## 23 BUSINESS AND/OR ORGANIZATION COMMENTS

# Submission 1037 (Gerald Cauthen, Bay Area Transportation Working Group, August 3, 2020)

## Response to Submission 1037 (Gerald Cauthen, Bay Area Transportation Working Group, August 3, 2020)

ATTACHMENT 7 VERTICAL CURVE DESIGN

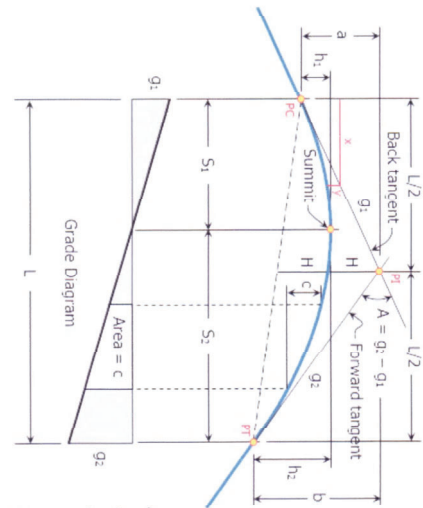
“Please add the below attached comment, "Second Request for Stop Work Order," to the Central Valley Wye Final Supplemental EIR/EIS. This comment concerns the dangerous track curve designs for HSR in graphic terminology in the hopes that the Operations or Maintenance Engineers within your organization will comprehend the danger of the curve designs and do the right thing.

ATTACHMENTS 6, 7, & 8 TO BE APPLIED SIMULTANEOUSLY, VERTICAL CURVE IS COMBINED WITH HORIZONTAL SPIRAL WHILE TRACKS ARE SUPERELEVATED FROM 0" TO 6" WHERE TRAINS TRAVEL AT 220 mph
